Subject: Meeting regarding Smoke Test Procedures

Cedar Grove Composting, Inc. Building Ventilation Test Procedures

PREPARED FOR: Puget Sound Clean Air Agency
COPY TO: Cedar Grove Composting, Inc.
PREPARED BY: Stacia Dugan/CH2M
DATE: April 13, 2017

Figure 2.

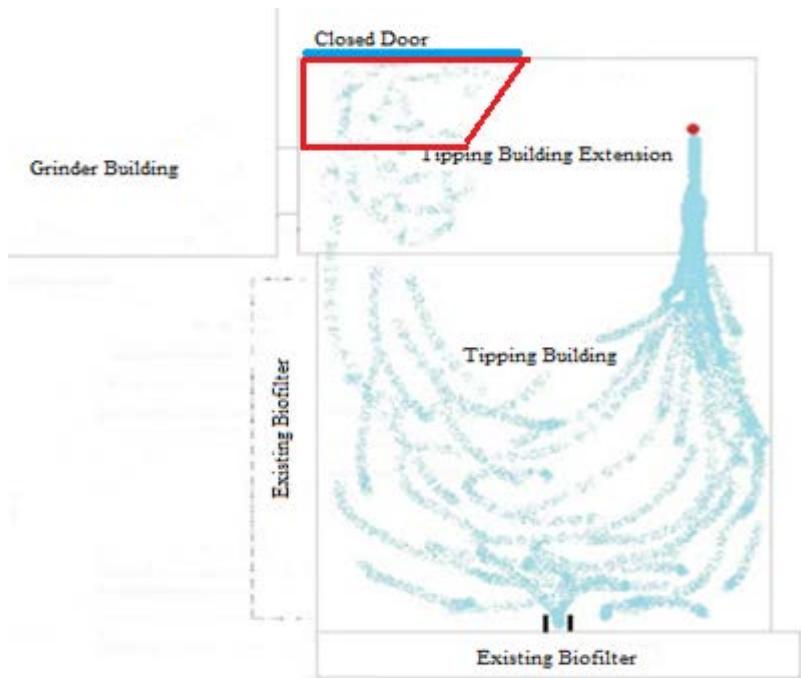
The smoke tests seem to indicate that there is an area, located between the door to the sorting building and the open door of the tipping building, where the pull of the ventilation system is not as strong as the rest of the building. We believe this is due to the air flow pattern created by the ventilation system. Cedar Grove has made adjustments to the position of the tipping extension intake; however, the changes have not demonstrated any significant change in the air flow pattern.

The flow pattern is similar, but also more complex, than the pattern indicated in Figure 1, a pattern created by PSCAA. The area outlined in red is area where it appears that the ventilation system has less pull. The excavator is frequently located in this area and no feedstock material is stored there.

It is important to understand that the intake behaves much like a vacuum. If you put your hand right in front of the vacuum the pull is strong, but as you move your hand further away the pull diminishes. However, air that is not in the direct pull of the vacuum moves toward the intake to fill the "void" or low pressure area created by the vacuum. Because the intake is near the ceiling, the air flow is not necessarily straight into the intake. It appears that air moves across the floor and then up the walls to the ceiling area in a vertical swirl pattern as well as the horizontal swirling pattern shown in the drawing. The smoke tends to concentrate in the main tipping building where the feedstock material is located, but a lighter concentration of smoke is present in the tipping building extension. There appears to be less pull by the ventilation system on the area between the grinding building doorway and the closed tipping building door which is probably caused by the fact that it is easier for the system to pull air in through the door to the sorting building and over the grinding area, than it is to pull the air on the other side of the grinding building doorway.
